PEPPERDINE UNIVERSITY

CAMPUS LIFE

Final Environmental Impact Report

March 31, 2011

View profile from Camping Area 4

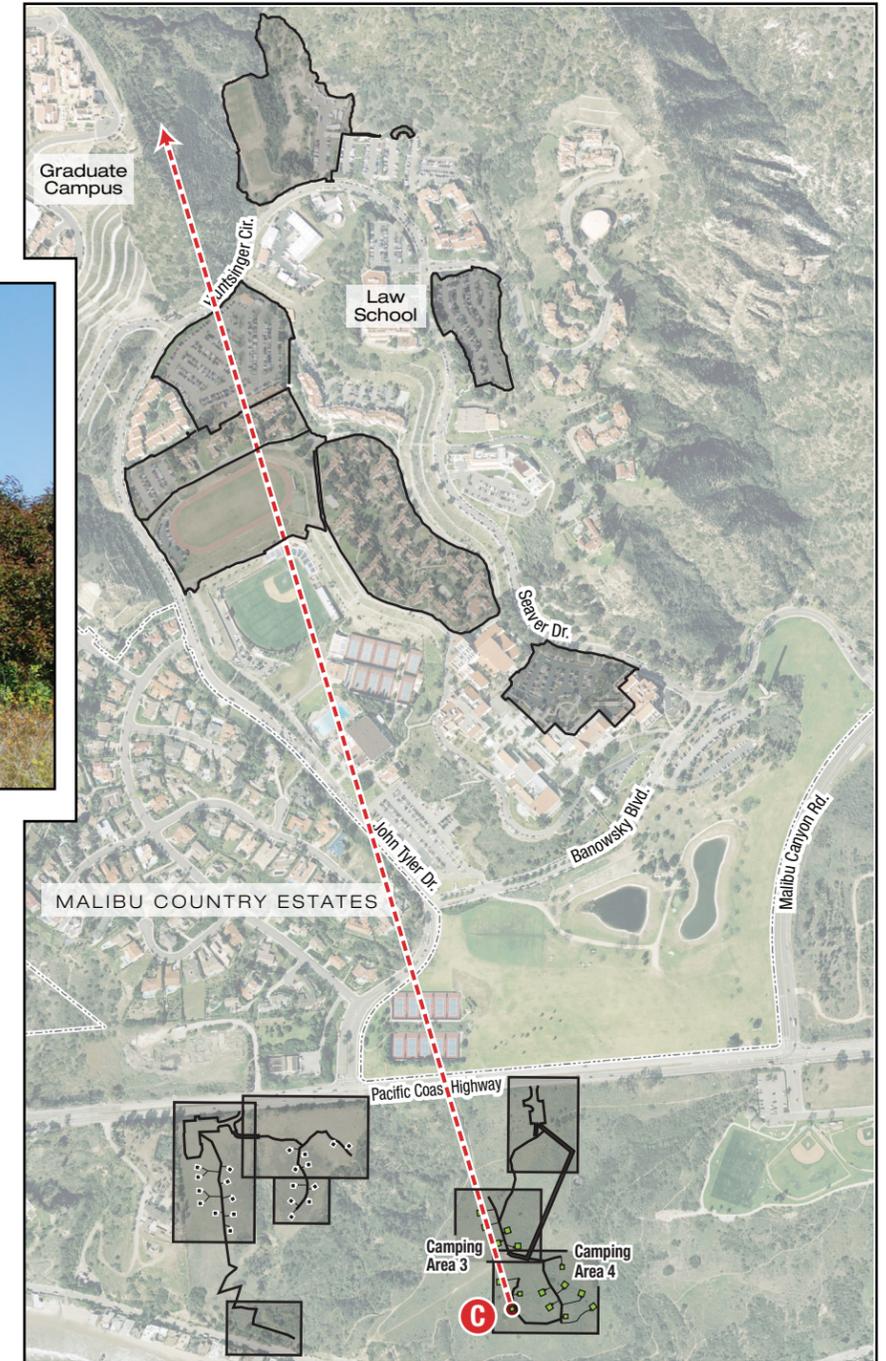
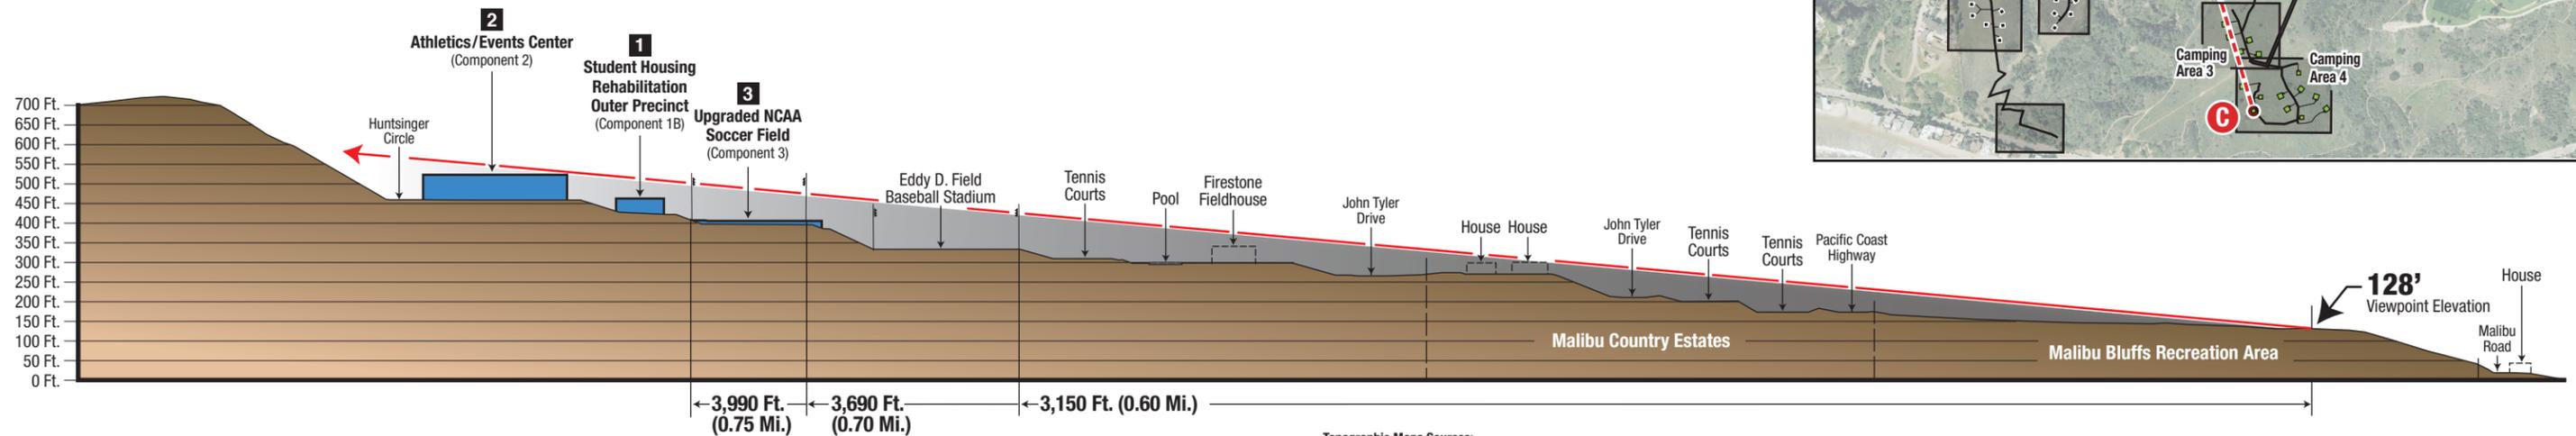
The illuminated field surfaces of Component 3 and 5 are situated at higher elevations and cannot be seen from any of the campsite locations at the Bluffs. The 14 campsites within Camping Areas 3 and 4 have visibility of the light poles proposed for Component 3 and, as illustrated by Profile C (**Figure 6**), they may also have some visibility of the tops of the light poles located at the related baseball field project. Because these campsites are located at distances of between 3,150 feet and 3,990 feet from the poles, from 0.6-0.7 miles away, visibility of the poles does not constitute a significant view obstruction. Despite some limited visibility of the light standards from these distances, the lighting sources and interior surfaces of the light fixture hoods themselves would not be visible from these campsites.

The elevation of Malibu Country Estates intervenes to block visibility of all athletics and recreation fields. The tops of light poles at Component 3 could be seen at distances between 3,150 feet and 3,990 feet from campsites in Camping Areas 3 and 4.

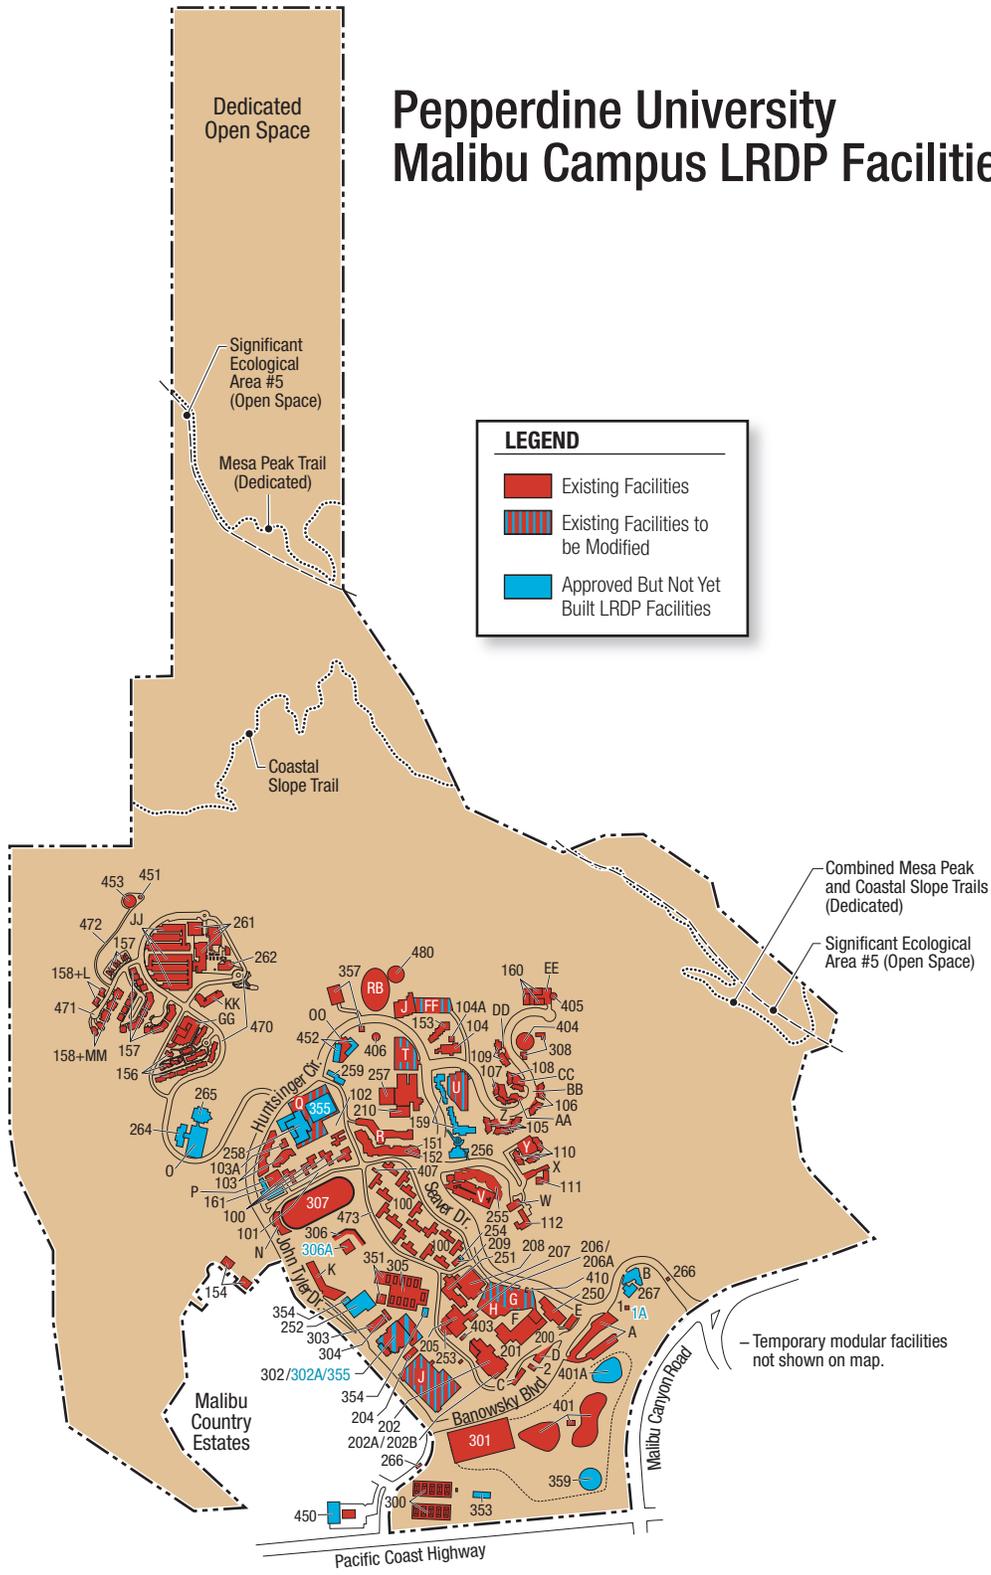
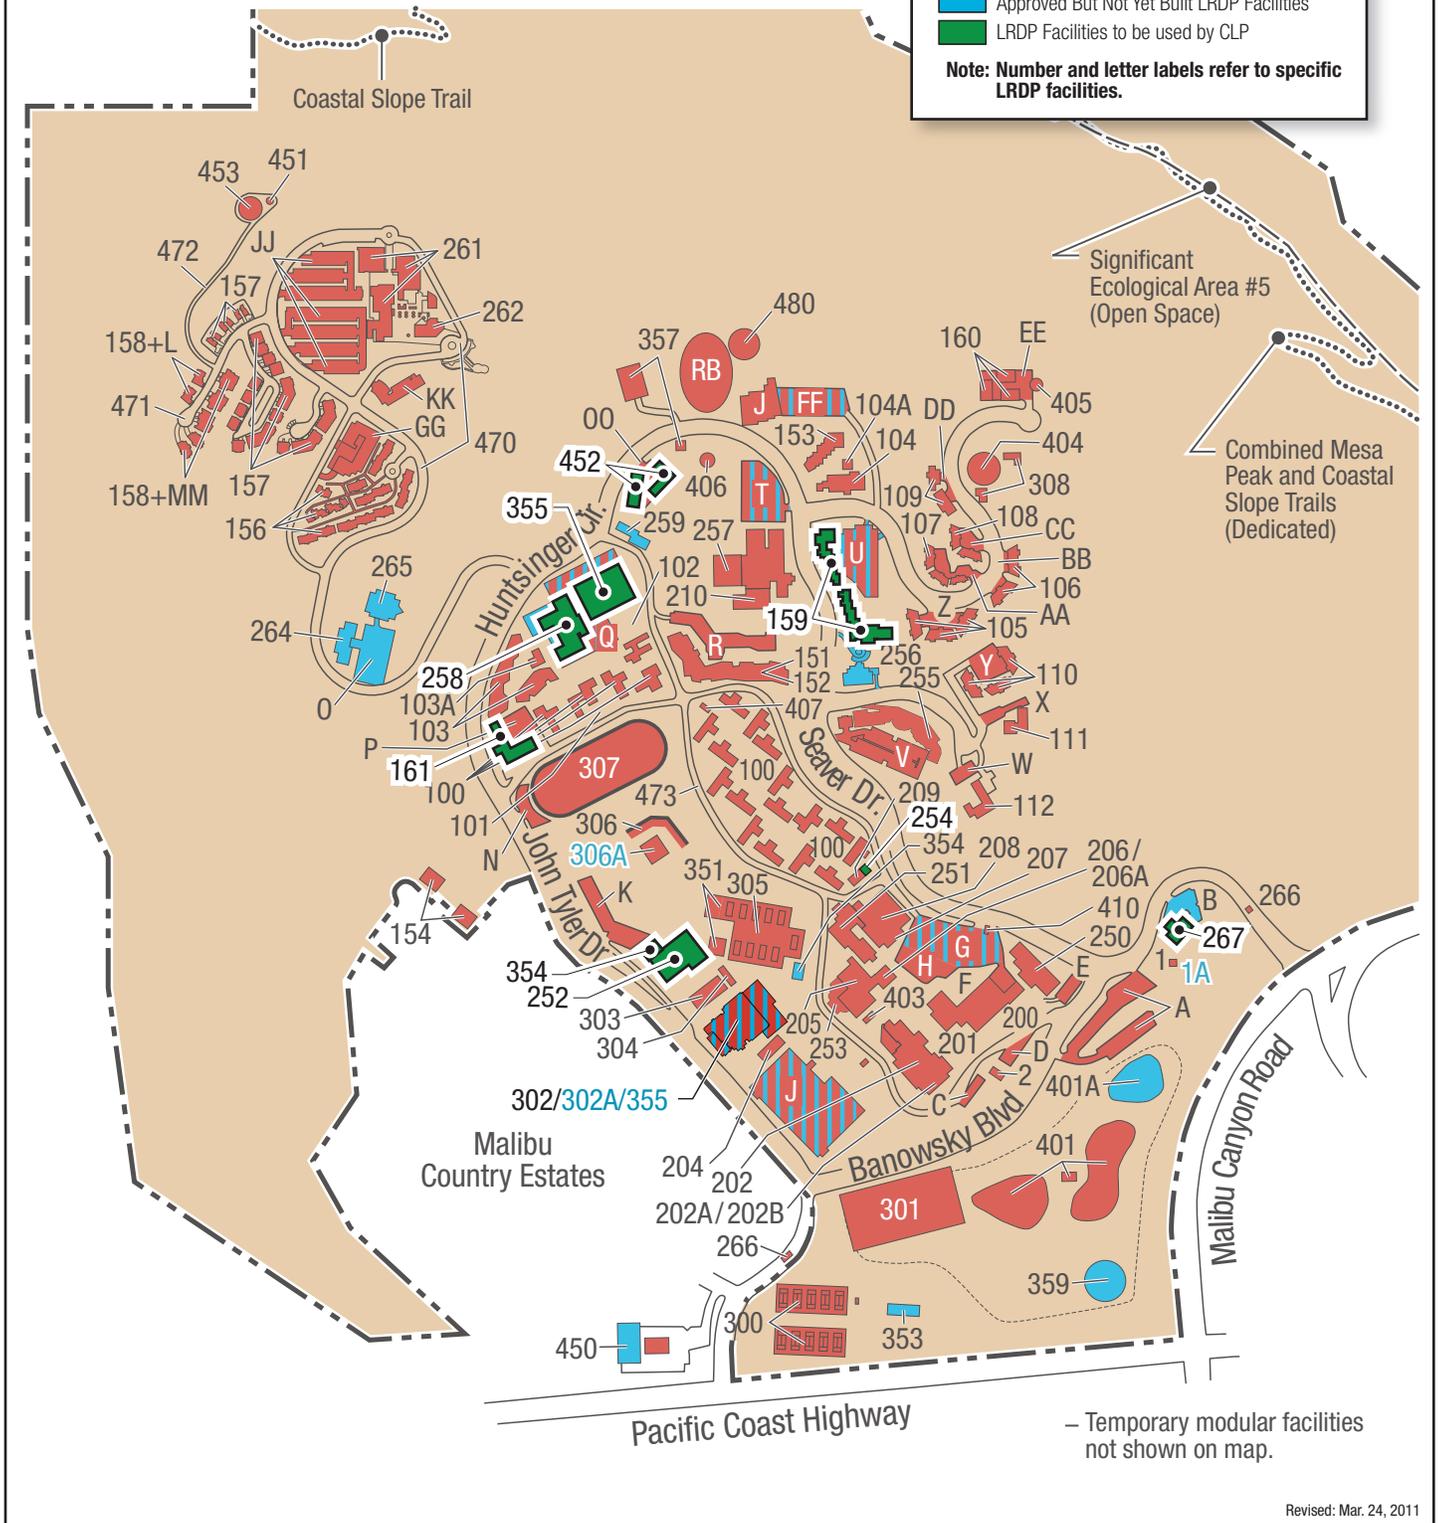
Based on a comparison of Figure 5.11-5 (“LRDP Facilities to be Utilized for the CLP”) and Figure 5.11-6 (“LRDP after CLP Approval”), it appears that the proposed Campus Life project would expand the footprint beyond the long range development plan (LRDP) in the Enhanced Recreation Area (Component Area 5). A Pepperdine representative indicated that these are conceptual figures and are not meant to show exact locations. Grading for the Enhanced Recreation Area would be 6.9 acres (DEIR, p. 5.7-22). It does not appear that the Long Range Development Plan (LRDP) contemplated a detention basin in the proposed location, nor an expanded recreational field. The current topography reflecting the base of the naturally vegetated Marie Canyon drainage (maintained occasionally according to a Pepperdine representative) before it enters the developed/hardscaped Pepperdine Campus would be filled and replaced by an expanded recreational field, and the debris basin would be moved to a location further up the canyon. Wildlife such as deer use this drainage.

78. pg. 5.11-8: Figure 5.11-4 should include a key to explain what each of the numbered facilities on the LRDP Map are. It would be especially helpful to at least identify the approved but not yet built LRDP facilities.

This comment questions the University's previously approved long-range development plan ("LRDP"), and the potential for wildlife such as deer to use the drainage in Marie Canyon. The figures in the DEIR referred to by the commenter (i.e., Figures 5.11-5 and 5.11-6) are intended to show only generalized locations of existing or proposed facilities. The shapes on the figures are not to scale, and the existing and approved facilities depicted on 5.11-5 are not reflective of the actual or proposed entitlements. Both

Table 5.11-3 identifies the approved LRDP/DPZ facilities with their corresponding CLP components, and the detailed campus map in DEIR Figure 5.11-5 illustrates their locations on the Pepperdine University campus.
